REMARKS

These remarks are in response to the non-final Office Action mailed 5/20/05, in which claims 1 – 15 are pending. Claims 1 – 6 and 10 – 15 are rejected. Claims 7 – 9 are objected to as being dependent upon a rejected base claim, but would be allowable if rewritten in independent form to include all of the limitations of the base claim and any intervening claims. The applicant gratefully acknowledges the fact that the Examiner has noted that claims 7 – 9 are drawn to allowable matter. Claims 2, 14, and 15 have been cancelled. Claim 1 was amended to incorporate the recitations of claim 2. Claim 3 was amended to depend from claim 1. Claim 7 was amended into independent form, incorporating the claim terms of claim 1. Claim 10 was amended to address an antecedent basis issue. No new matter was added during any of the claim amendments.

FIG. 4

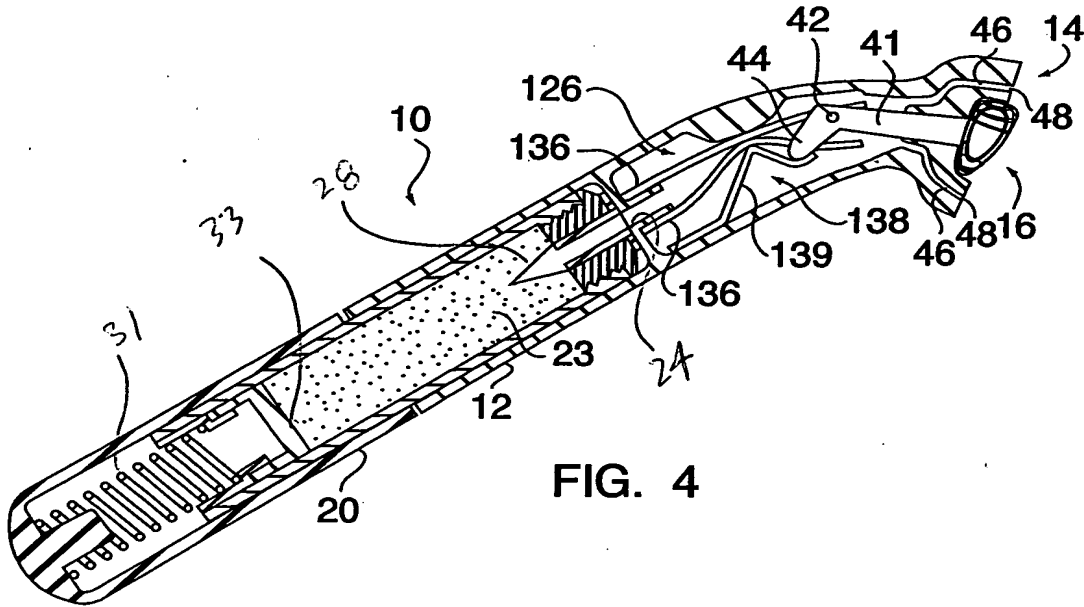
The applicant has amended the specification and the drawings. Figure 4 has been amended to include identifiers 24, 28, 30, and 31 that were unintentionally omitted from the original drawings. In light of the amendments, it is requested that the Examiner withdraw the objection to the drawings.

FIG. 5

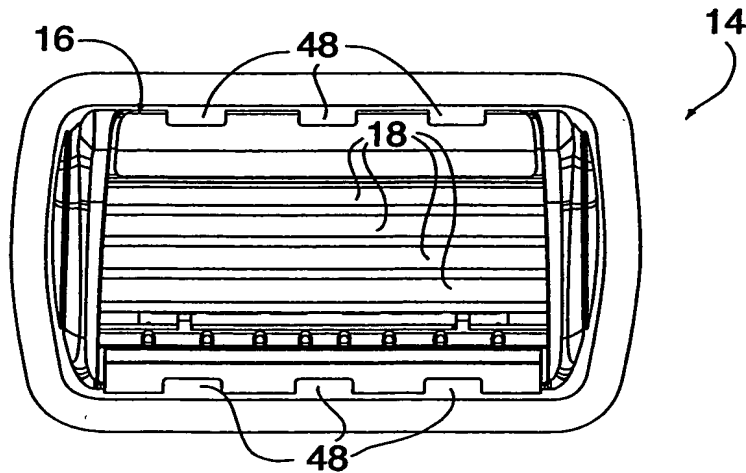
Paragraphs [0011.1] and [0011.2] were added to provide brief descriptions of FIG. 5. Paragraphs [0019] and [0023] were amended to identify the subject figure in each instance. The changes made were for solely for clarification purposes. Paragraph
